HUTCHINSON/MAYRATH

Bulletin: #16-03

Product Release Bulletin

Klean Sweep Features

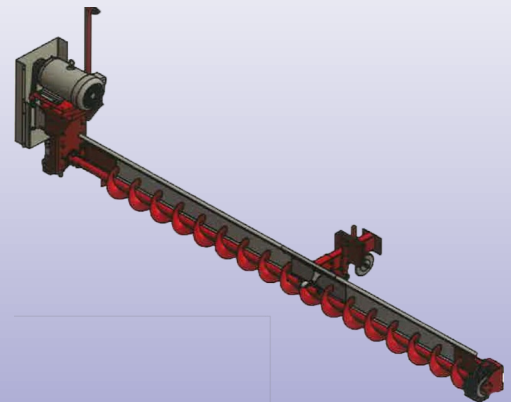
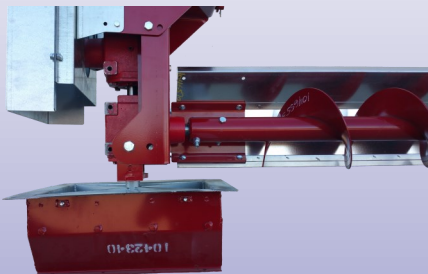
Product Improvement Overview: The 810 and 1012 Series Commercial Klean Sweeps have been re-designed with a 2.25:1 double gearbox drive to allow for the sweep to be positioned closer to the floor. The sweeps also incorporate the new sweep end wheel with a cycloidal gear reducer located inside the wheel. A new carrier will also be included with sweeps for 48' and larger bins. The new carrier sits behind the sweep for less interference as the sweep drives into the grain.
